UNITED STATES
NUCLEAR REGULATORY COMMISSION
WASHINGTON, D.C. 20555-0001

SUBJECT: PERRY NUCLEAR POWER PLANT, UNIT 1 – SAFETY EVALUATION
REGARDING IMPLEMENTATION OF MITIGATING STRATEGIES AND
RELIABLE SPENT FUEL INSTRUMENTATION RELATED TO ORDERS
EA-12-049 AND EA-12-051 (CAC NOS. MF0962 AND MF0802)

PERRY NUCLEAR POWER PLANT, UNIT 1

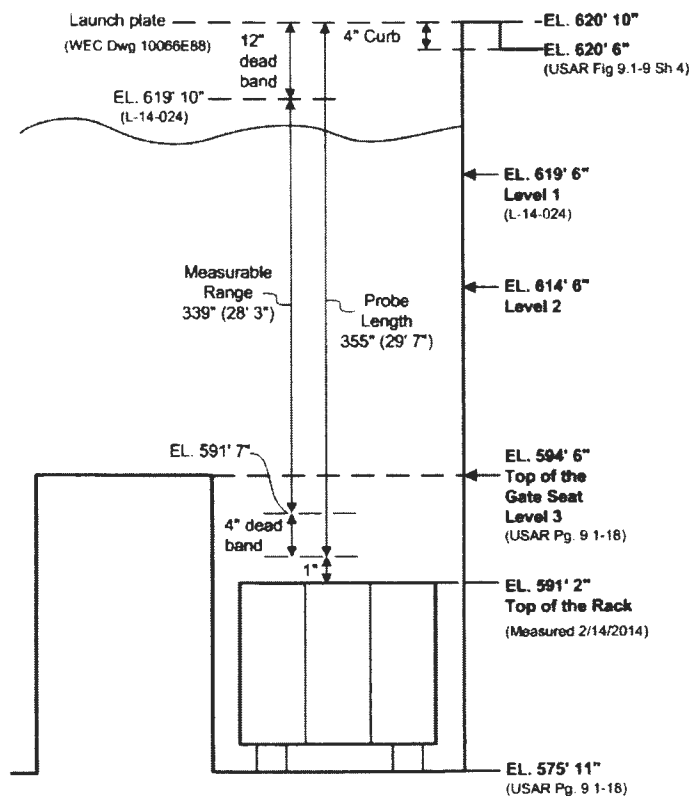
The licensee provided a response by letter dated July 2, 2013 [Reference 38], in which it stated that:

No other means of removing water from the SFP exist above the skimmers. Therefore, the identified location is the highest point of the two options described in the NEI 12-02 guidance for Level 1 and is the level that is adequate to support operation of the normal fuel pool cooling system.

NEI 12-02 allows the licensee to use 10 feet (+/- 1 foot) above the highest point of any fuel rack seated in the SFPs as Level 2. FENOC has chosen this option for PNPP. NEI 12-02, Section 2.3.2 states that "Level 2 represents the range of water level where any necessary operations in the vicinity of the SFP can be completed without significant dose consequences from direct gamma radiation from the stored spent fuel." Level 2 is associated with dose rates from the fuel; therefore, it is not adjusted based on varied dose rates from other items in the pool. FENOC has selected guided wave radar as its technology, which provides continuous level indication from Level 1 through Level 3. Data will be available for mitigation strategies to be initiated, when deemed appropriate, based on water levels between Level 1 and Level 3. FENOC recognizes additional materials stored in the SFP may cause the area to become uninhabitable prior to the monitored Level 2. FENOC also recognizes that the location of these additional materials is subject to change during each refueling outage. Therefore, FENOC does not plan to adjust Level 2, but instead address the potential dose rates associated with other material through alternate means. FENOC plans to evaluate the other materials in the SFP for relocation or removal in support of mitigation strategies. Based on fuel pool material configuration and projected dose levels, FENOC plans to develop an early method to keep those materials adequately covered using mitigation strategies or a manual make-up capability from a location not impacted by the dose rate. Mitigation strategies for addressing increased doses to personnel in the SFP area associated with other materials in the pool in a beyond-design-basis accident is to be addressed via PNPP FLEX procedures, as needed.

By letter dated August 28, 2014 [Reference 42], the licensee provided the change on Level 2 elevation as below:
